DOUGLAS, SUTTON & UXBRIDGE PLANNING BOARDS
Meeting Minutes
March 11, 2021

March 11, 2021

Blackstone Logistics Center

Uxbridge, Douglas & Sutton, Massachusetts

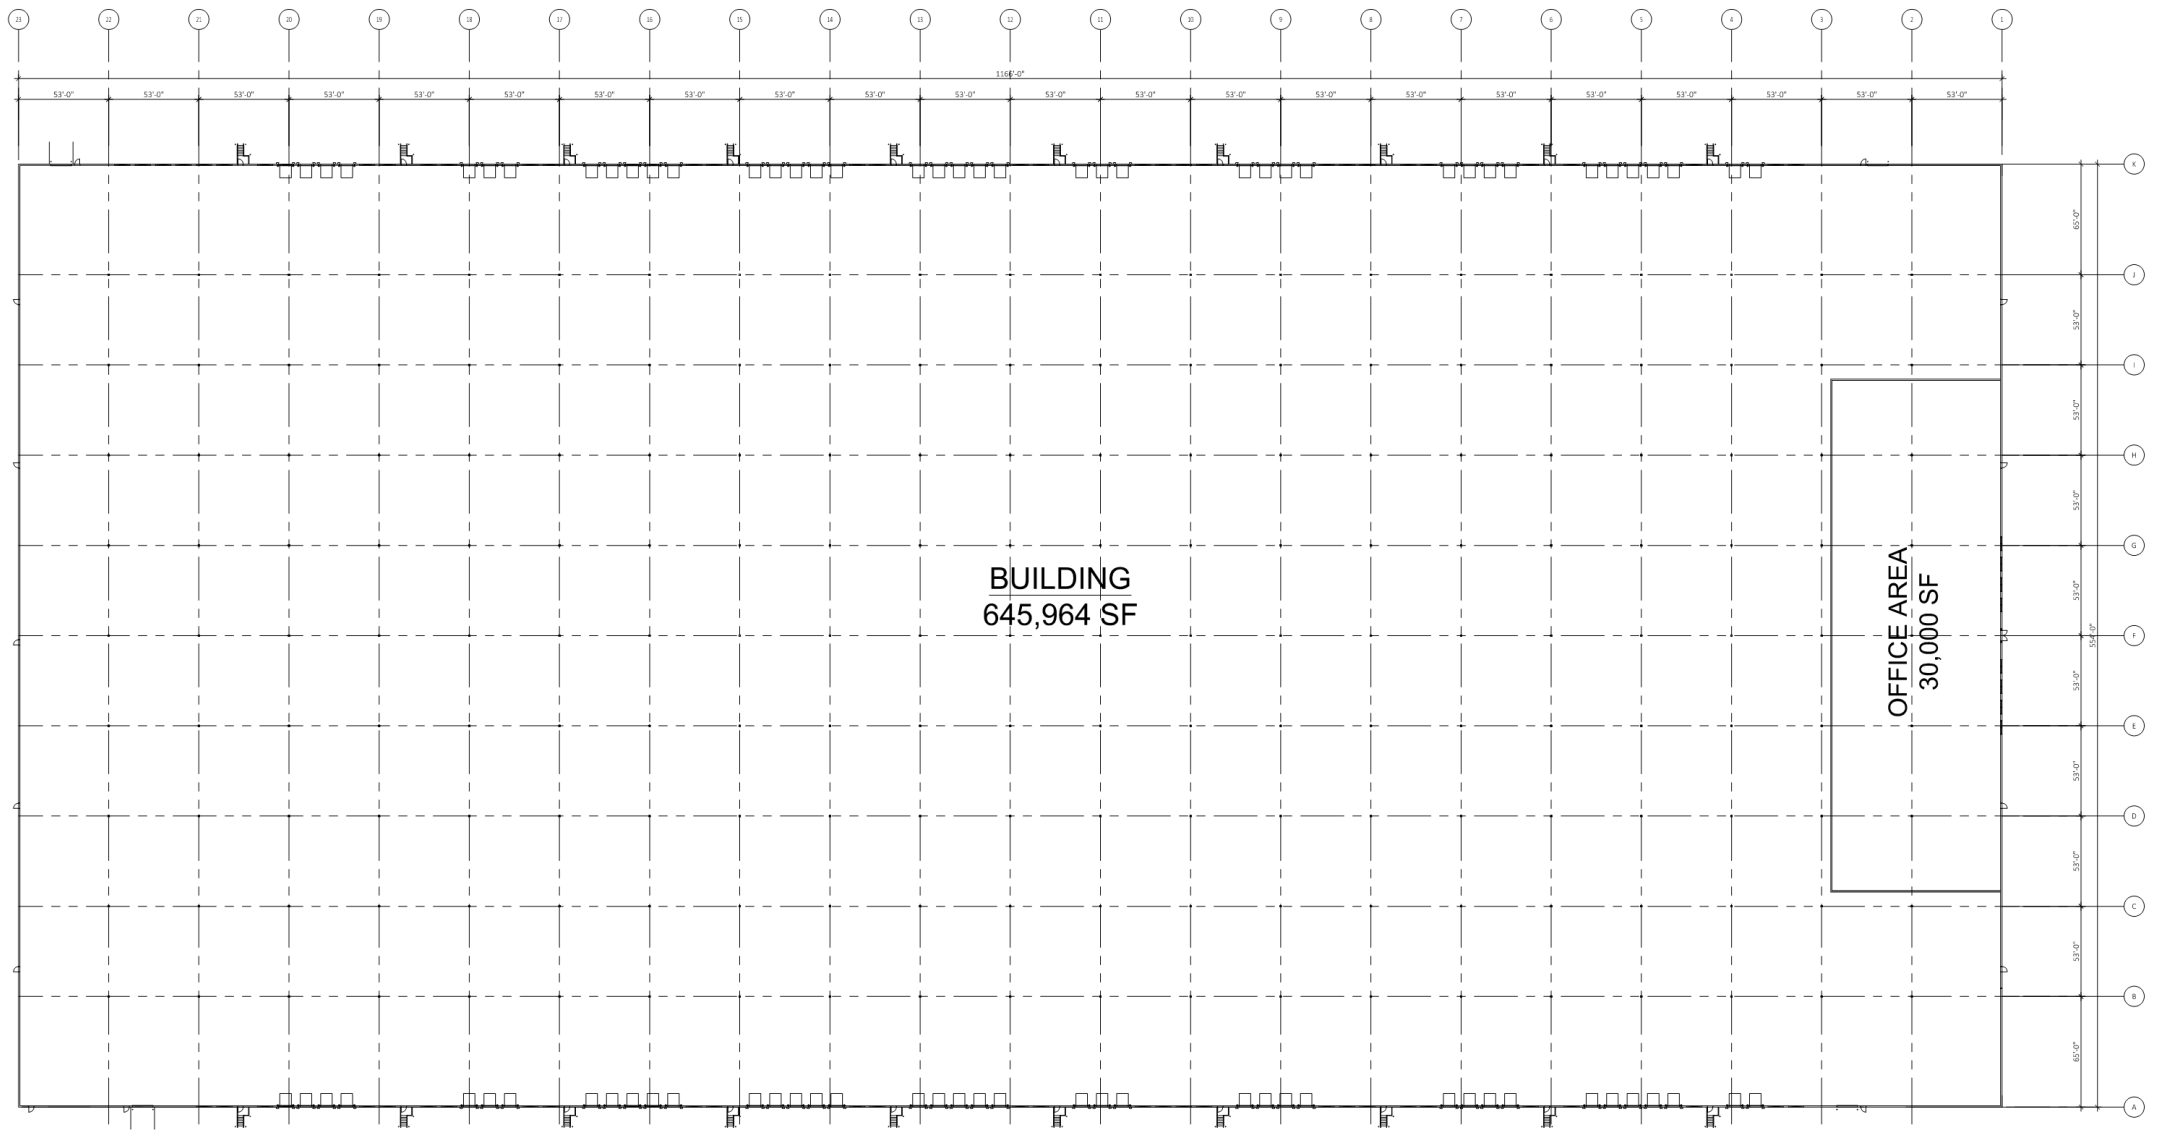
E. Laverdiere wants to see the views from both directions on Lackey Dam Road. He stated he expects to see significant landscaping to help these residents.

J. Hager, Sutton Planning Director noted the color scheme is very good but the front architecture needs work, perhaps pulling the office section forward and/or more depth or character on the front of the building to avoid just a HUGE rectangle with no character. There also needs to be a lot more landscaping along Lackey Dam Road. She noted there will always be a condition to ensure intended landscaping screening is achieved.

M. Gallerani echoed J. Hager's comments, noting the office should bump out at least slightly and there should be architecture or features that pay tribute to the Blackstone Valley and makes what the neighborhood sees more aesthetic.

Truck Queuing Exhibit
For Trucks Entering Facility

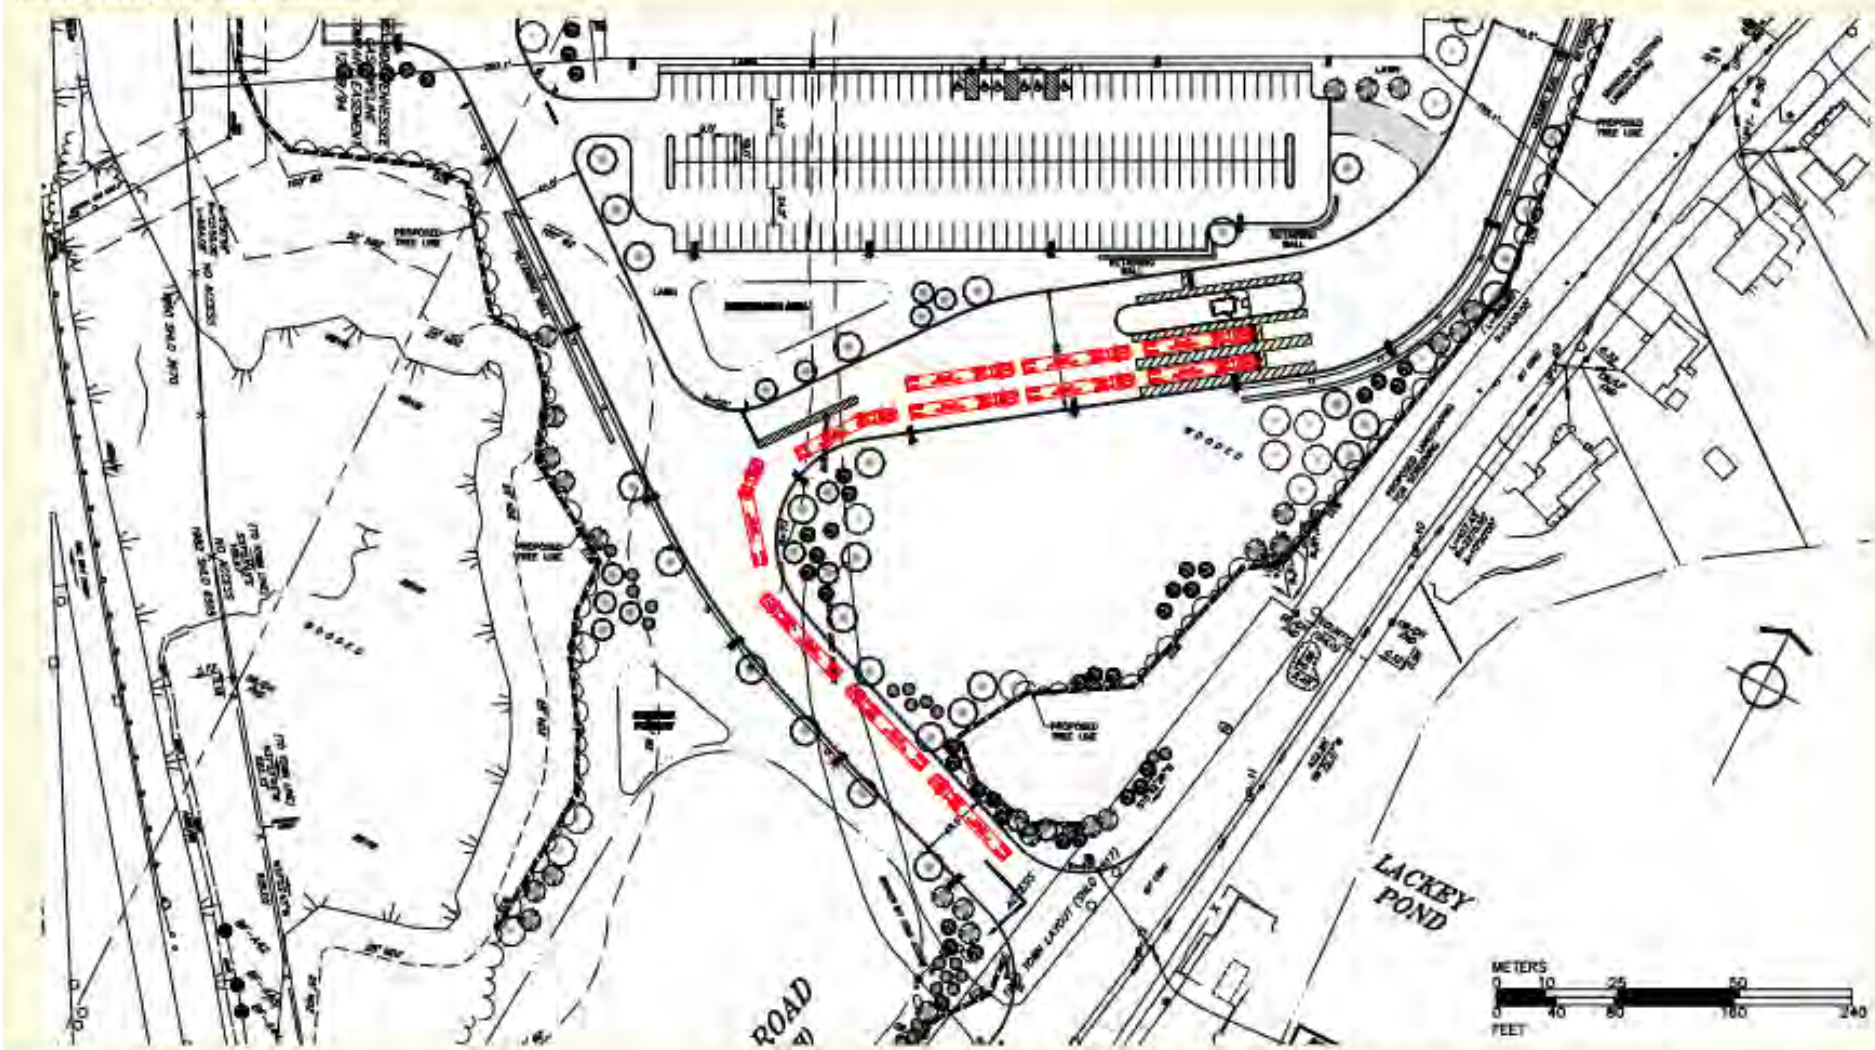
M. Zwicker asked if the entrance lane is single or dual to allow trucks to queue to the right and employees to pass on the left. He expressed concerns with headlight glare onto adjacent neighbors 24 hours a day.

M. Zwicker added the stacking lane on Lackey Dam also needs to consider employees.

D. Feeney stated there will be no truck washing on the site and they will determine where removal of snow and ice from truck tops can be accommodated. It is only one lane entering but they will look at whether it can be striped for two lanes.
